UZBEKISTAN GAS TO LIQUID PROJECT (UZGTL)

HAZOP ACTION CLOSE-OUT REGISTER FOR MAKE-UP H2 COMPRESSOR PACKAGE

UZGTL-HDC-HSE-RP-50-0-0004

NOTES

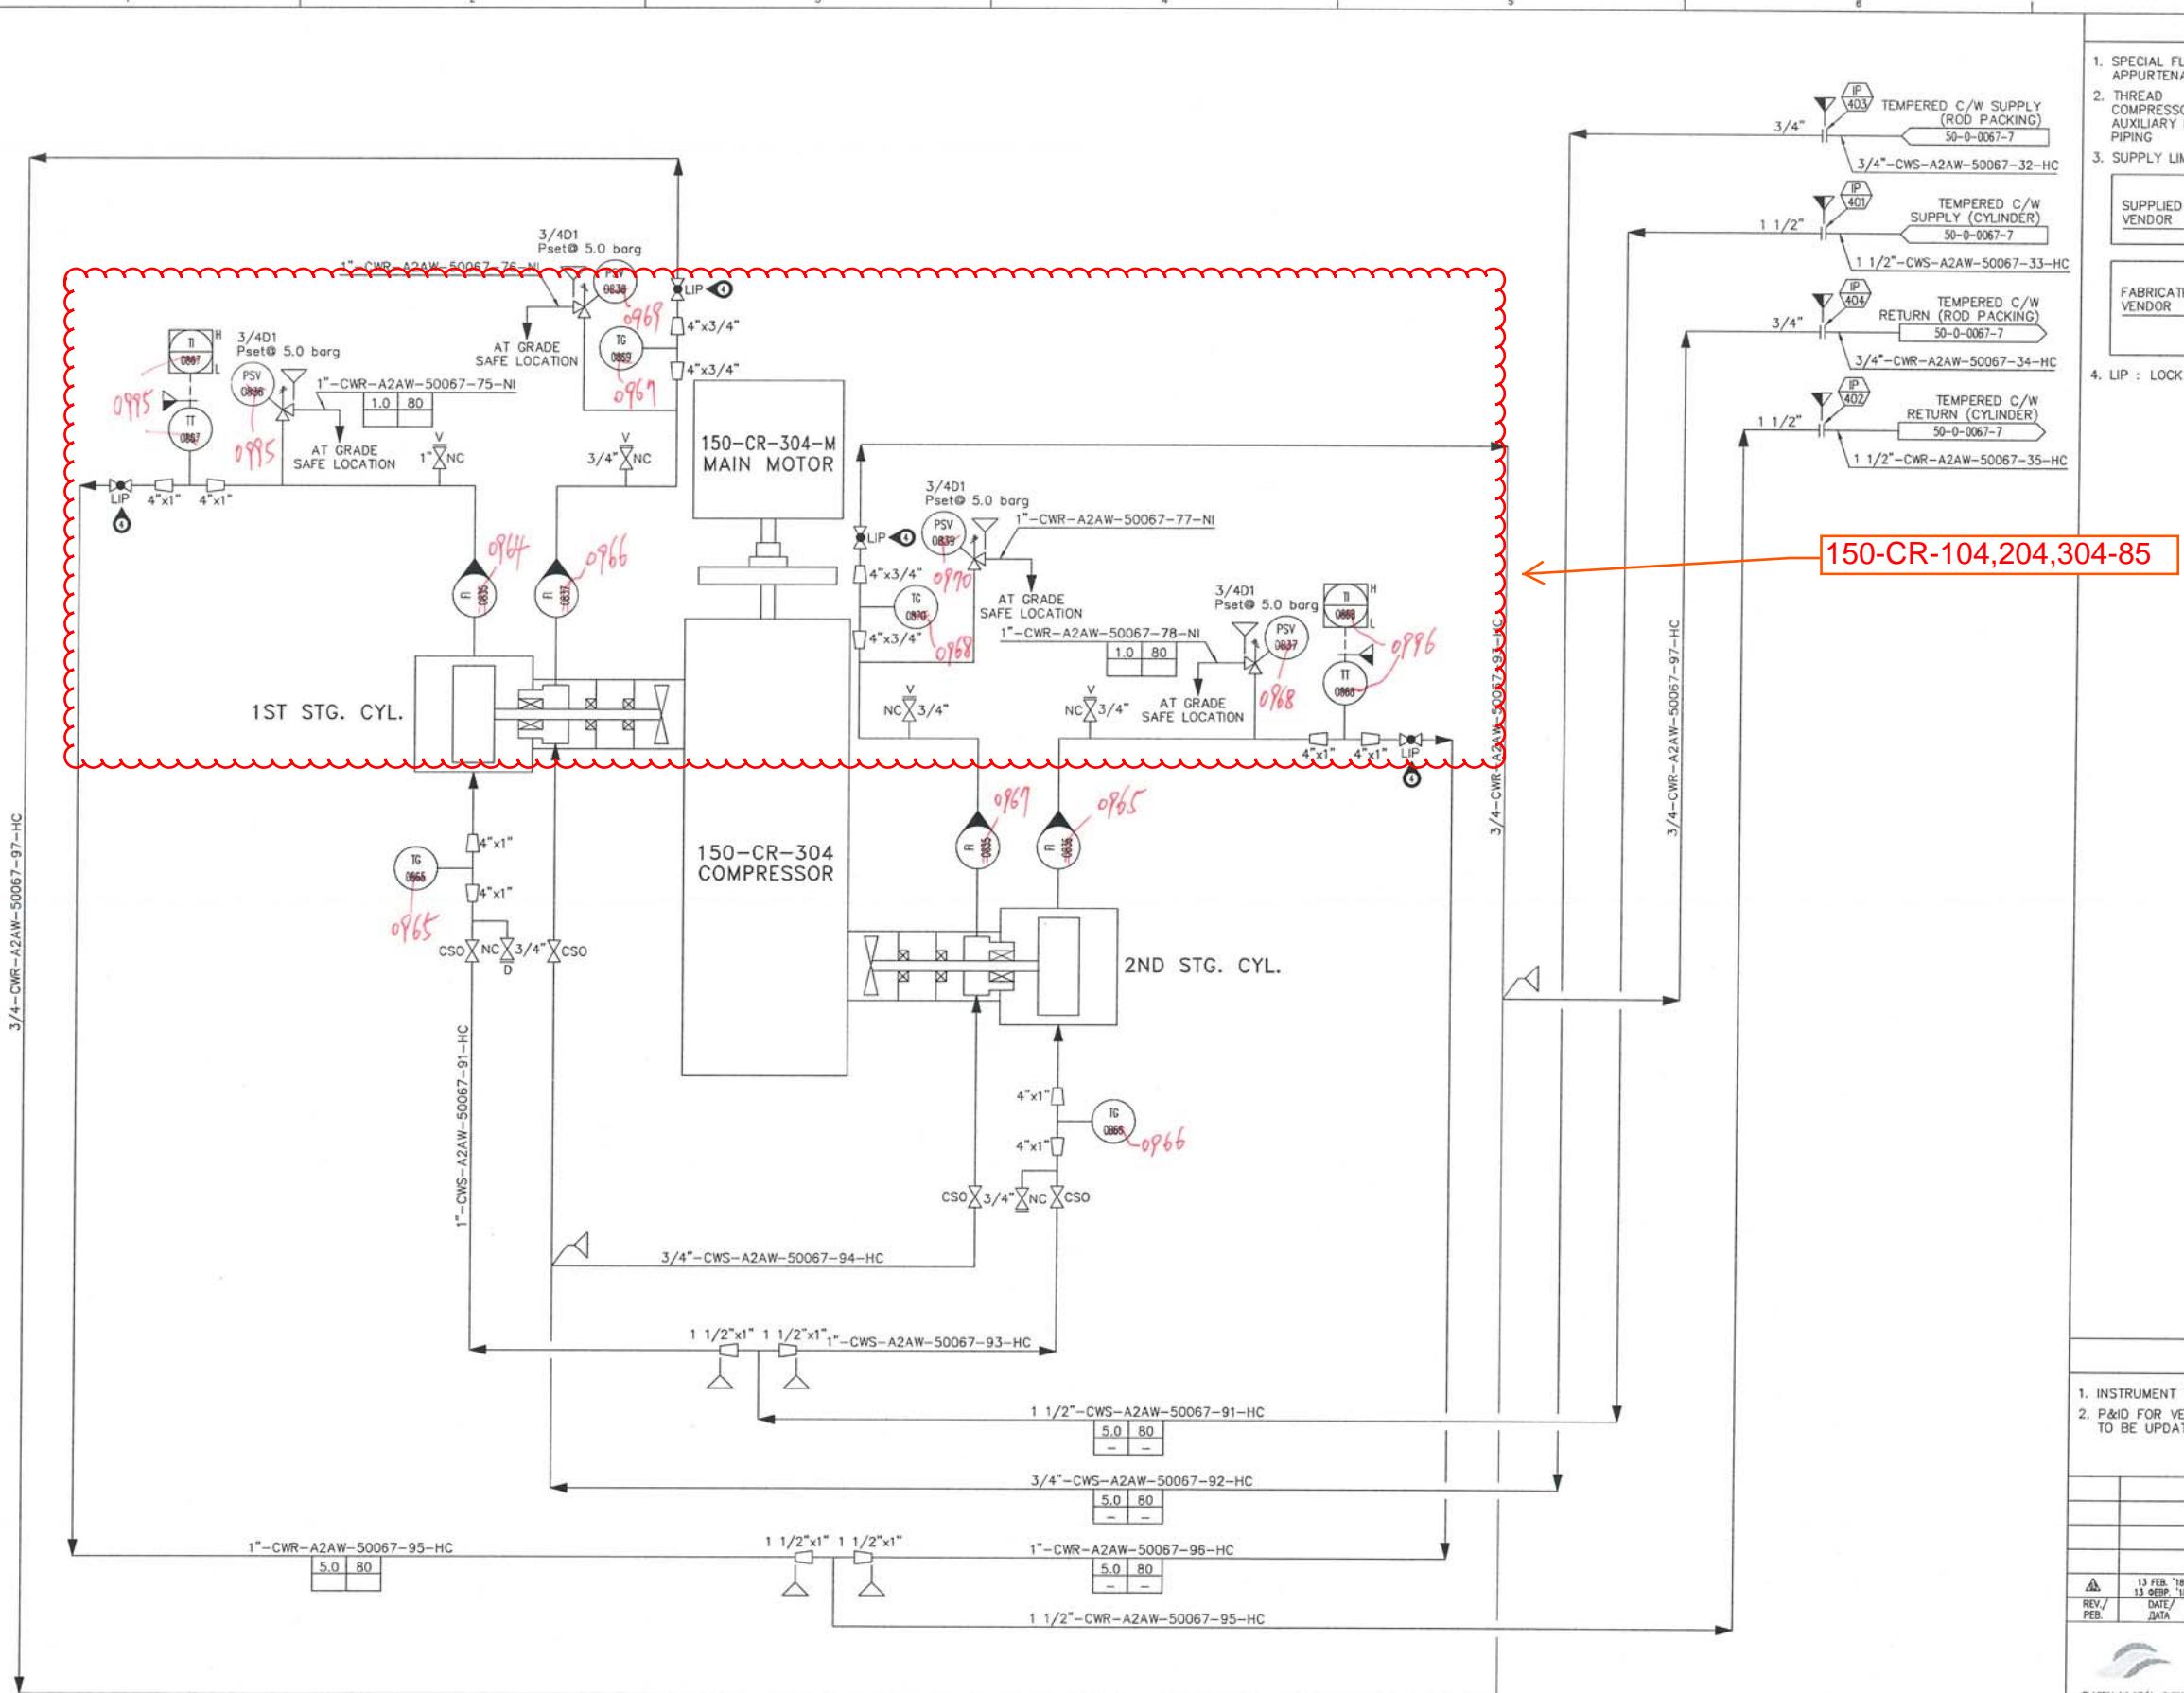
Action No.	150-CR-104/204/304-85				
Action By	PR				
Node No.	3				
Node Description	3. Cooling Water / TCW console				
Cause	3.9.1. Less Temperature of Cooling Water due to 150-TIC-0872A control loop malfunction or failure (150-TV-0832A close)				
Consequence	3.9.1.1. Potential condensate formation of process gas leading to potential piston ring lifetime decrease.				
Safeguards					
Action	Configure 150-TAL-0867A/0868A on DCS				
Response	Incorporated on P&ID (50-0-0065/66/67-6). 150-TAL-0867A/0868A on DCS is provided on AFC P&ID. (Please refer to attached P&ID, UZGTL-HDC-PRO-07-50-0-0065/66/67-6)				
CONTRACTOR			OWNER		
Position	Signature	Date	Position	Signature	Date
Process Engineer	<u>B.M.Hwang</u> 	10-Apr-2018		_____
